RFI 109

Project: COOLEY LABORATORY RENOVATION
Job: 3146 COOLEY LAB, PPA# 10-0023
Customer: STOFMT MSU BOZEMAN
Issued To: CONSTRUCTION MANAGEMENT SERV.
P.O. BOX 7274
BOZEMAN, MT 59715

Item: 4" AND 3" ISOLATION STEAM VALVES Type: MECH
Reference: M3.1 Spec. Section:
Attachments:

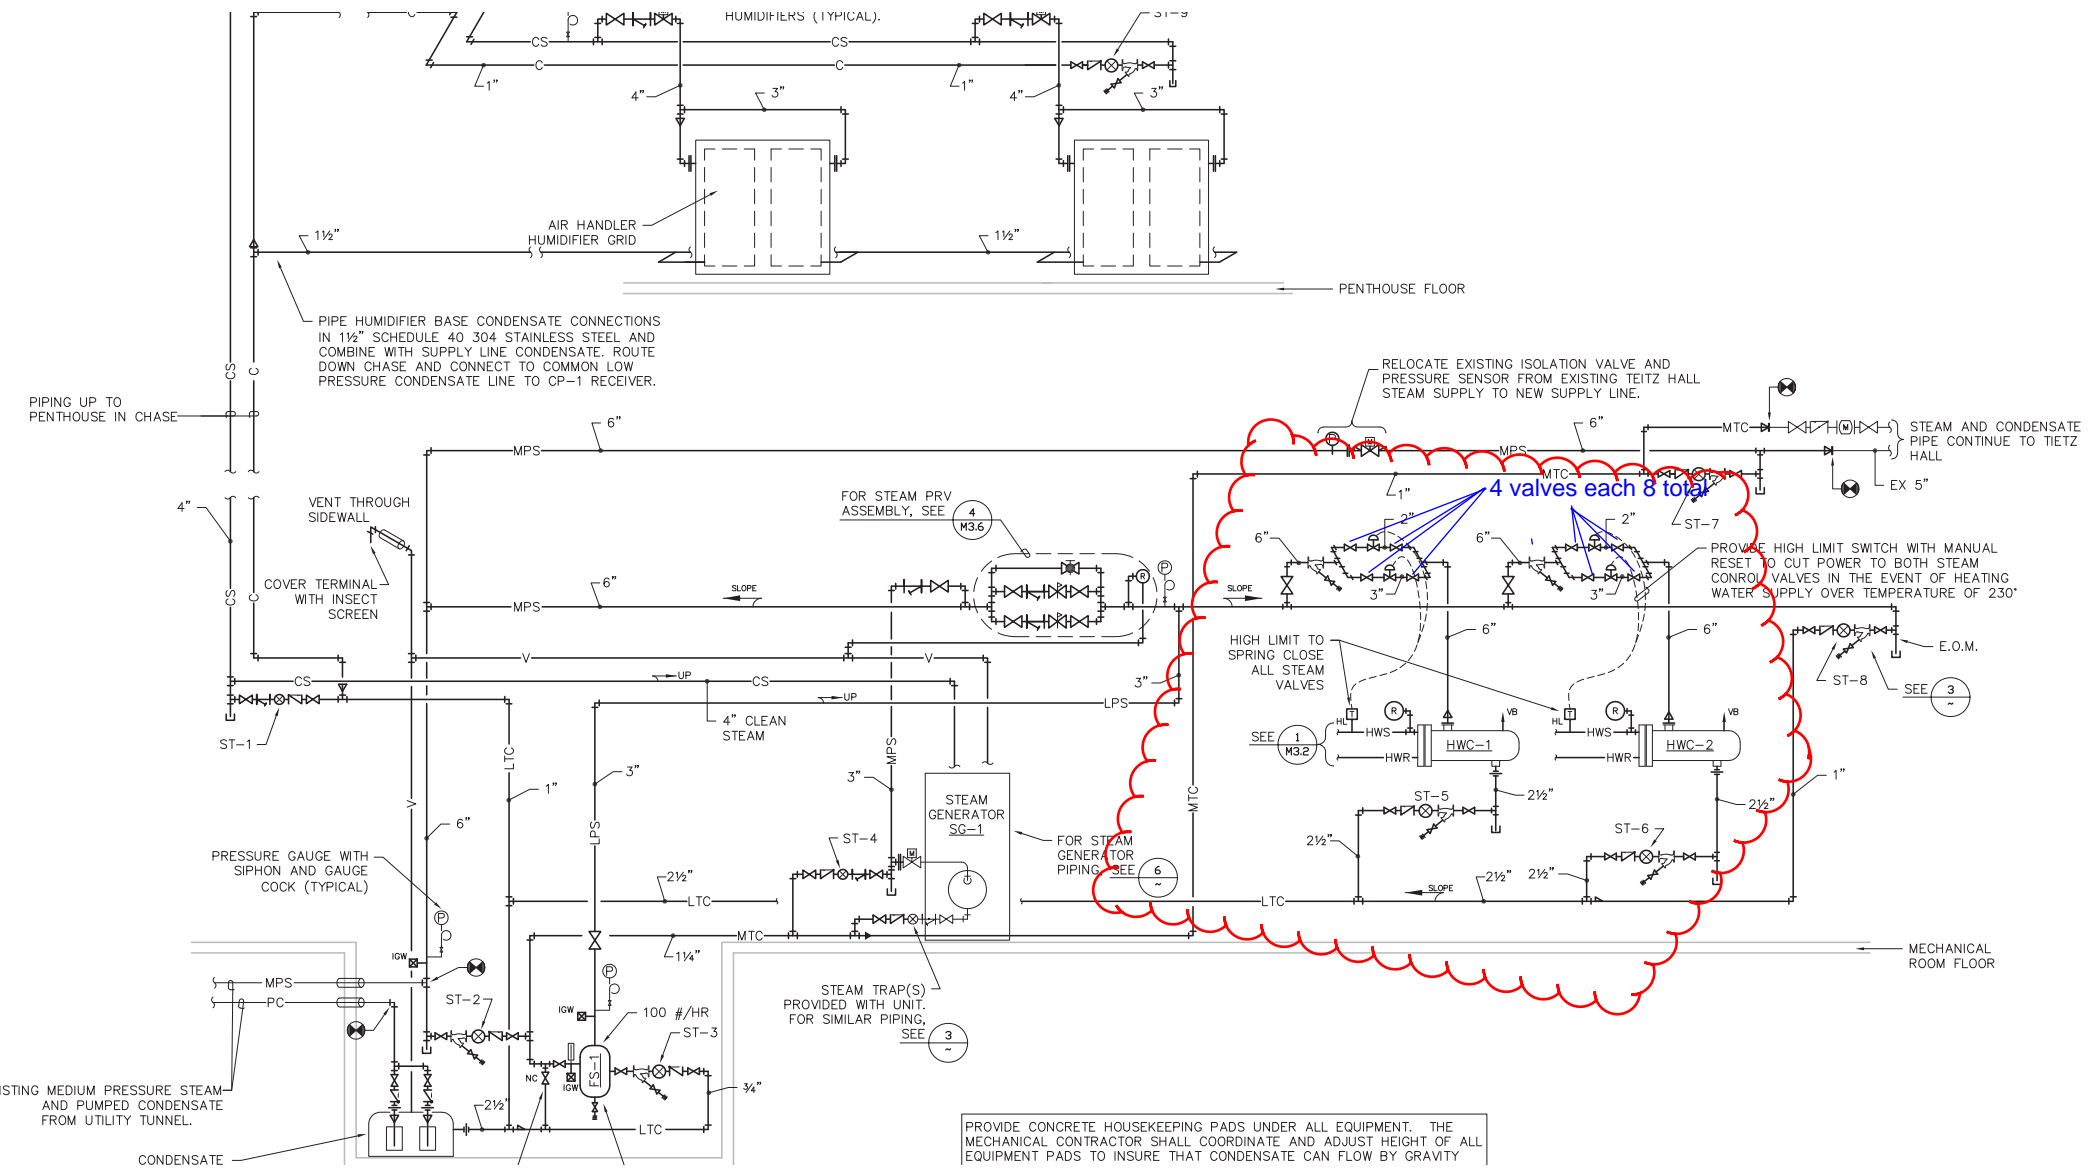
QUESTION:
Shown on drawing M3.1 Detail 1 there are 2 sets of 2/3, 1/3 steam modulating valve headers. One set for each of the 2 heat exchangers. Each of these steam headers have redundant isolation valves before and after the modulating valves. We would propose to eliminate the 2-3" valves and the 2-4" valves in each of the modulating valve headers for the following reasons:

- 1) There is little room for these valves and it will make them not easily accessible.
- 2) There is no isolation gain as we already have a 6" valve upstream for each header and a condensation valve before and after the wye strainer blow down. Either of these headers can be used for isolation and maintenance or repair without these additional valves allowing the alternate header to continue providing steam over water heat.

Please advise if this is acceptable.

4 valves each 8 total

The deletion of the 8 valves is acceptable. Please provide pricing -
